Responses to NRC Questions on River Bend Station  
Plant Transient Analysis Methodology, Supplement 1,  
EA-PT-91-0003-SP

February 17, 1993

Thermal/Hydraulic Analysis Group  
Engineering Analysis Section  
Engineering Department  
River Bend Nuclear Group  
Gulf States Utilities

Figure 1 Reactivity as a function of time for TT1.

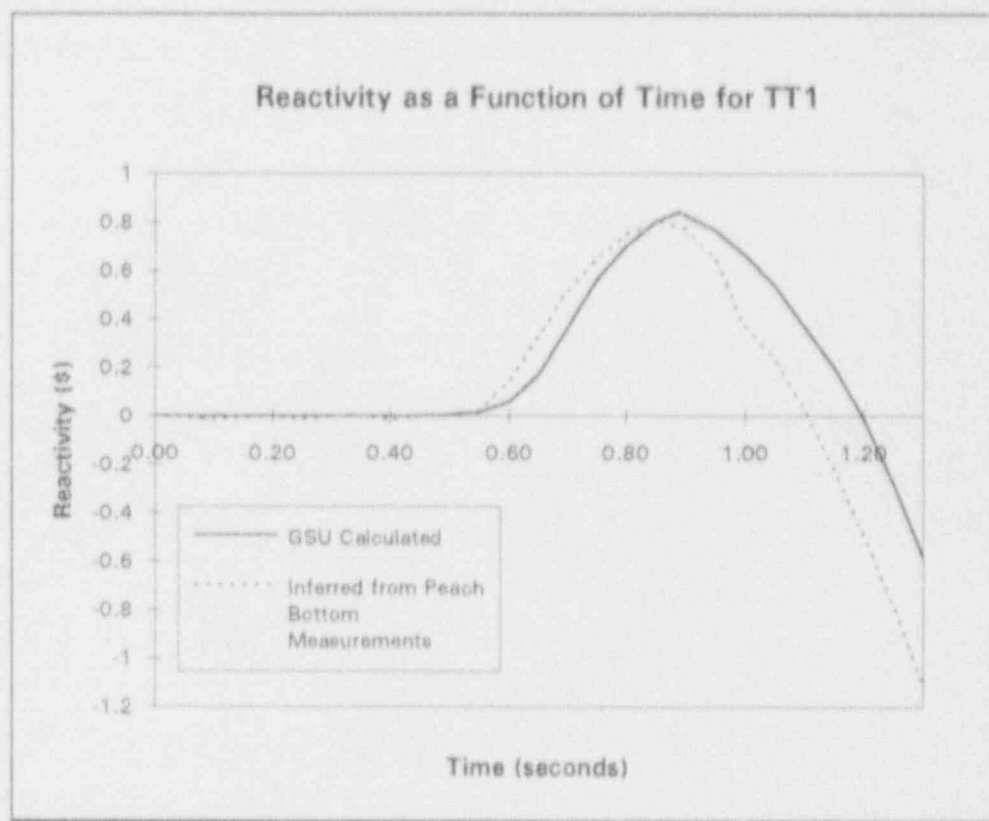
The scram and doppler reactivity contributions to the excessive reactivity are relatively small initially, but ultimately increase sufficiently to dominate the excess reactivity and terminate the transient. How does the calculated reactivity compare with the reactivity inferred from the Peach Bottom 2 measurements, as a function of time, up to the point of minimum CPR? Justify the use of the uncertainty in the peak excess reactivity for the scram and doppler reactivity uncertainties.

Core power is strongly dependent upon excess reactivity, so changes in total reactivity are mirrored by changes in power. In References 1 and 2, GSU chose to compare the time dependent calculations to the directly measured parameter, core power, for each of the Peach Bottom 2 turbine trip tests. In Section 6.1.2 of Reference 2, the peak reactivity of the Peach Bottom turbine trip tests was inferred from the point reactor kinetics equation, and is therefore proportional to  $(1/\text{Power})(d\text{Power}/dt)$ . A comparison of the calculated and inferred reactivities for TT1 as a function of time is shown in Figure 1.

The point reactor kinetics equation was used to help quantify the uncertainty in kinetics parameters in units of reactivity. GSU compared the inferred reactivity from each of the Peach Bottom tests to calculated excess reactivity. The standard deviation in peak excess reactivity was used as a convenient single measure of the adequacy of the neutronics data (i.e., two group cross sections, delayed neutron fractions, decay

- 1) Being proportional to the derivative of the power spike rate, peak excess reactivity is a good indicator of the transient response including void and Doppler feedbacks, just prior to rod insertion, and
- 2) Although scram worth is a strong feedback, its contribution to the transient uncertainty is small since once an axial portion of the core is fully controlled, power generation in that portion is dramatically reduced. The major uncertainty associated with scram is the timing of the scram, not the rod worth. Scram time uncertainty is treated separately in the GSU methodology.

Figure 2 Scram insertion rate used for various events.

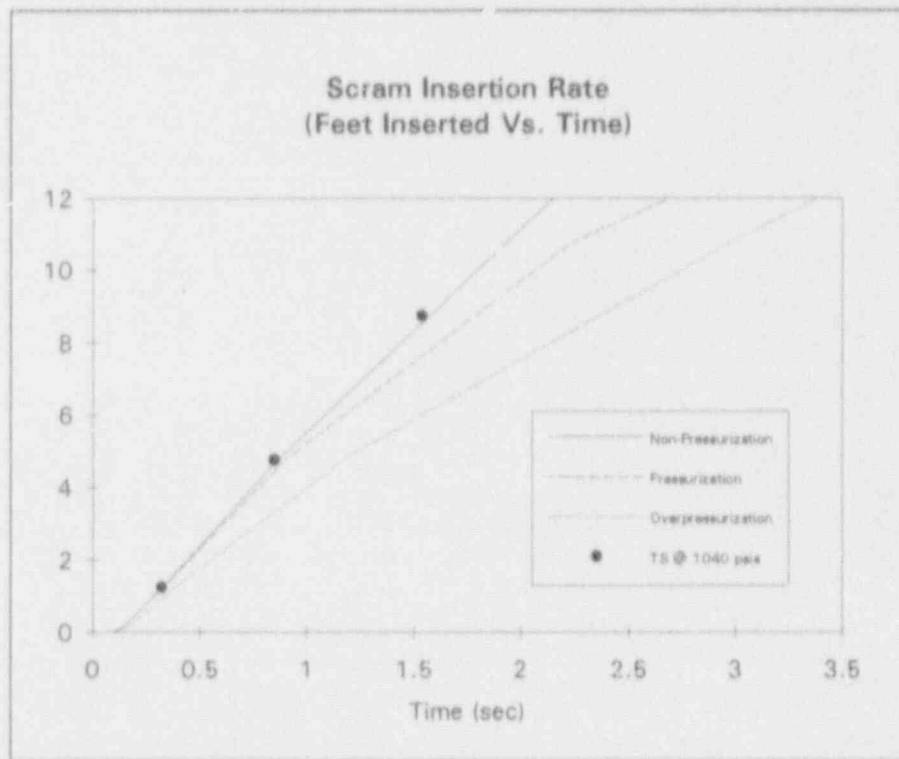
Discuss the difference between the control rod insertion curves for the pressurization and overpressurization events.

The scram function of the control rods is accomplished by scram accumulators located at the hydraulic control unit of each control rod. The accumulator is partially filled with water, and is maintained at a relatively high pressure by means of a nitrogen blanket. Upon receipt of a scram signal, the scram valves open, admitting the water in the accumulator to below the drive piston, which causes the control rod to rapidly insert against reactor pressure. Therefore, the rate of insertion is dependent upon the reactor pressure.

The overpressurization event results in higher vessel pressures during the insertion of control rods than pressurization and non-pressurization events. Therefore, the rate at which the control rods are inserted is slower for the overpressurization transient. The insertion rates used by GSU are the same as those used by the fuel vendor. Figure 2 below shows the nominal scram rates used for evaluation of non-pressurization, pressurization, and overpressurization events. Also shown is the Technical Specification scram speed requirement for reactor dome pressure of 1040 psia. Note that all scram curves used for non-pressurization, pressurization, and overpressurization events are more conservative than the Technical Specification requirement.
